ASSY TOP

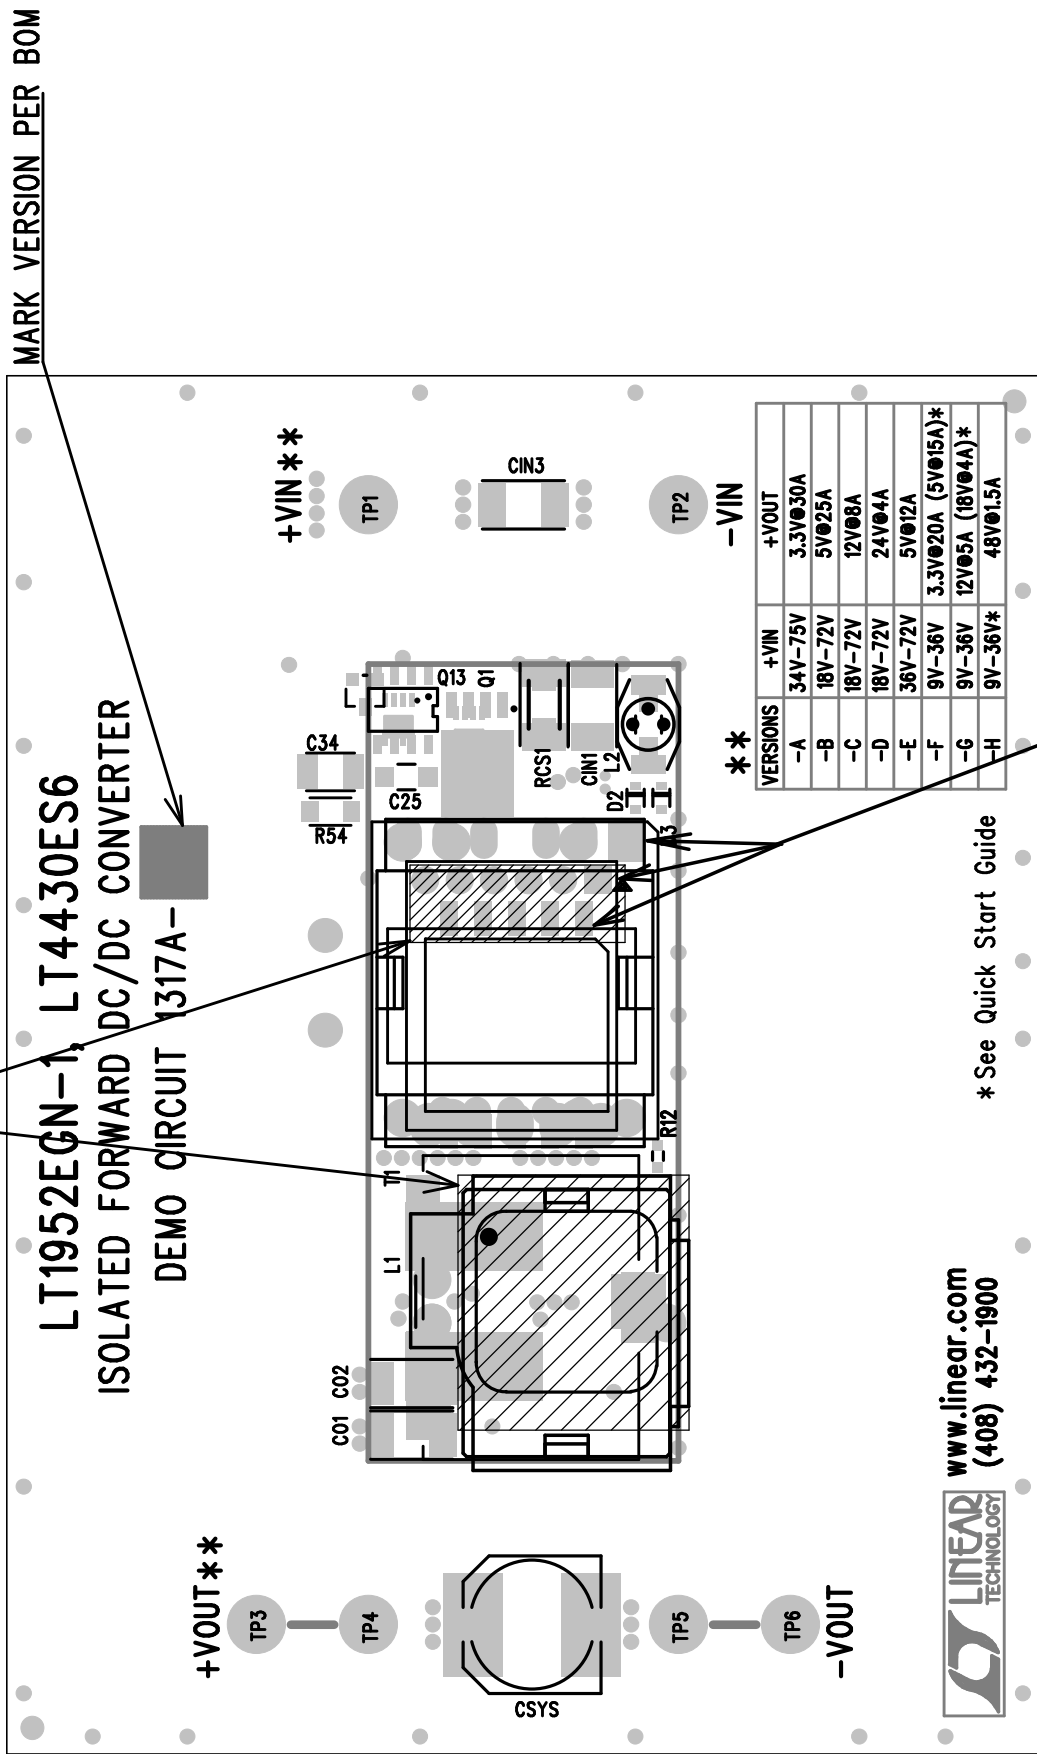
Because of multiple footprint in this design.
Place a piece of kapton tape on board as shown
to insulate T1 and L1 from open copper. No solder
under kapton tape area (tape off the stencil opening
for not used pads under T1 and L1).
